Vanderbilt Corridor and One Vanderbilt (CEQR No. 14DCP188M)
Draft Final Scope of Work for a
Draft Environmental Impact Statement

Vanderbilt Corridor and One Vanderbilt

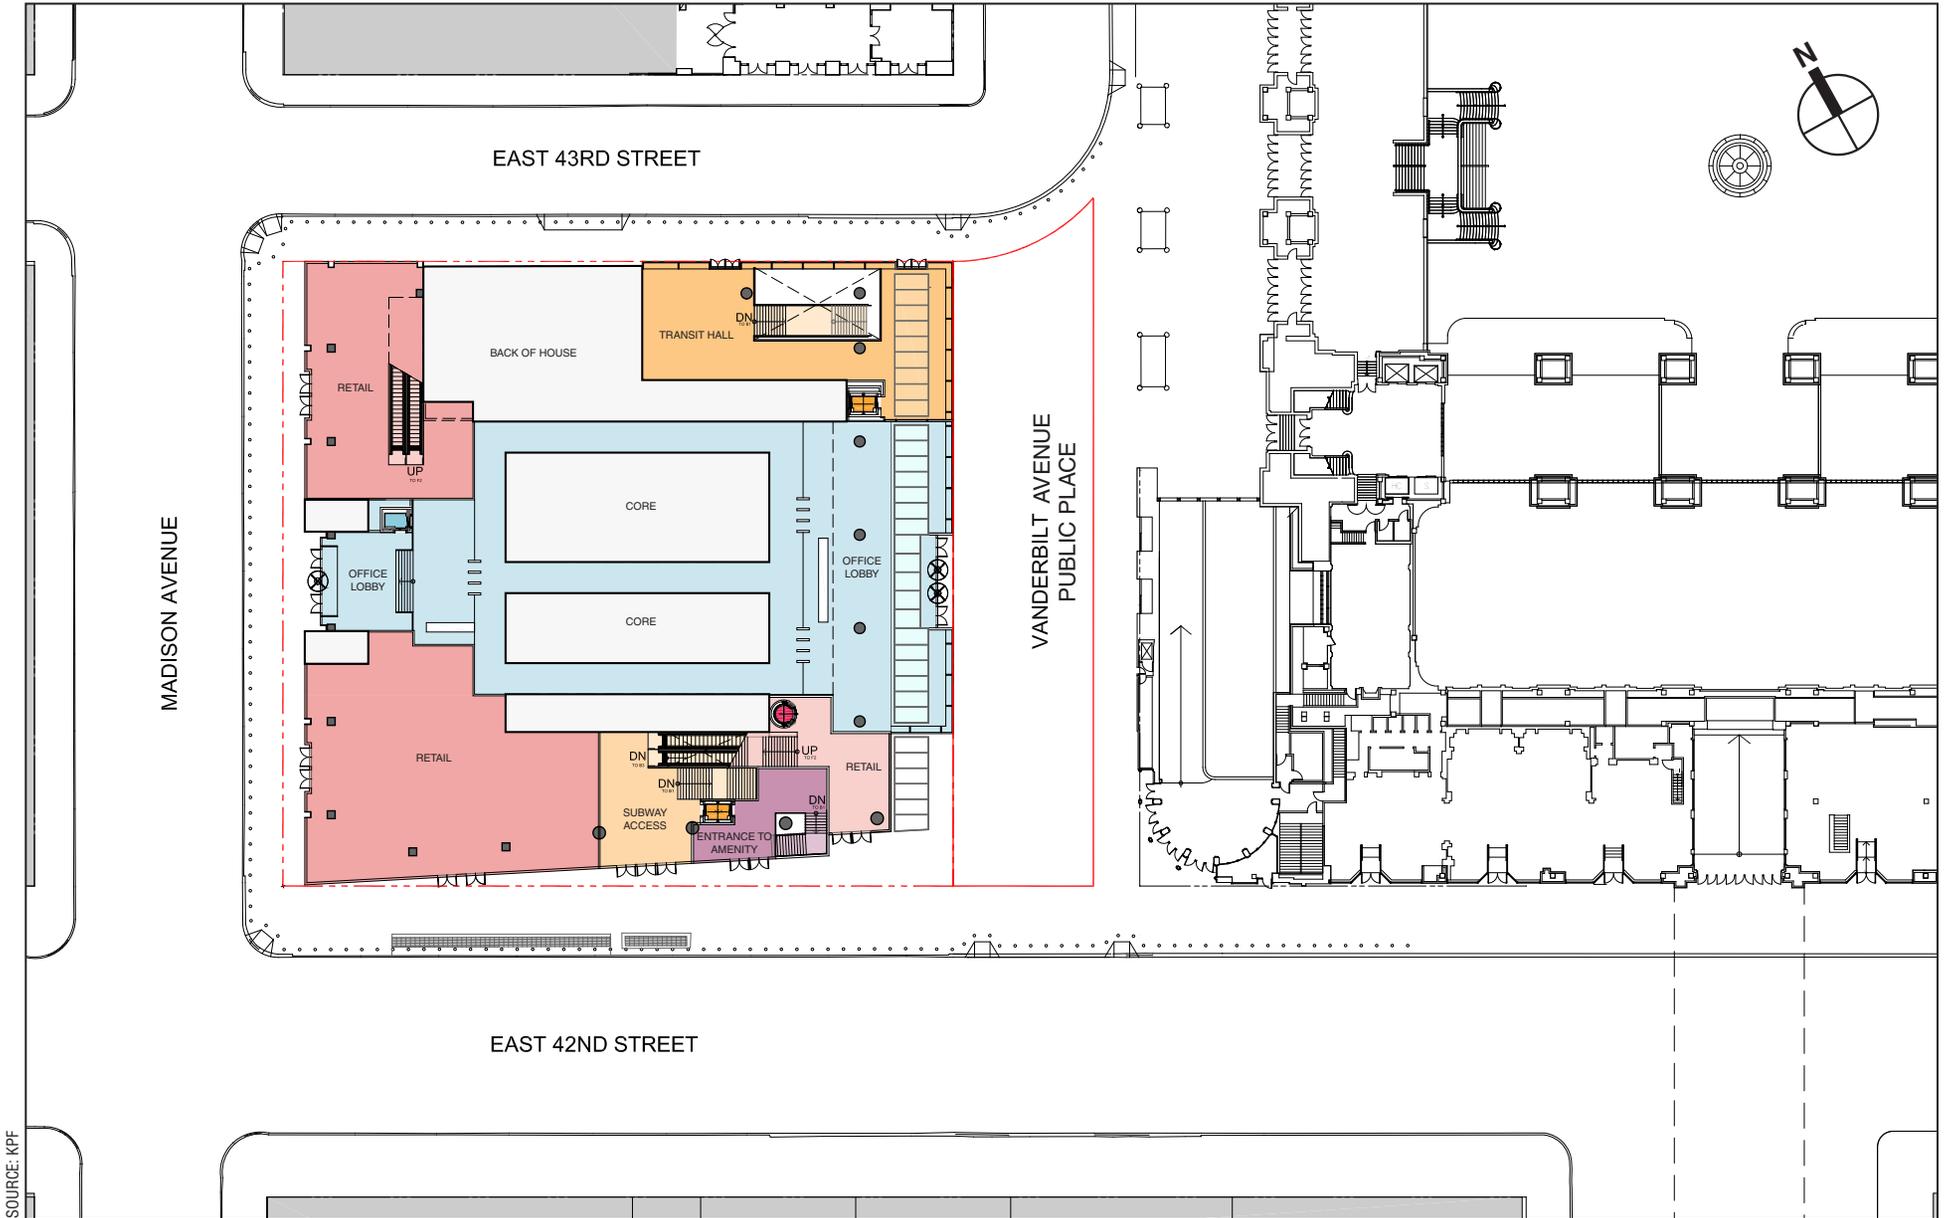
Figure 3 in the Draft Scope and the text on page 4 suggests that the waiting room/foyer will only include a staircase to the concourse level and not include an elevator or escalators. What parameters were used to determine the placement of the elevator at the East 42 Street subway entrance in One Vanderbilt? Why not place the elevator inside the East Side Access waiting room/foyer? (Tri-Board)
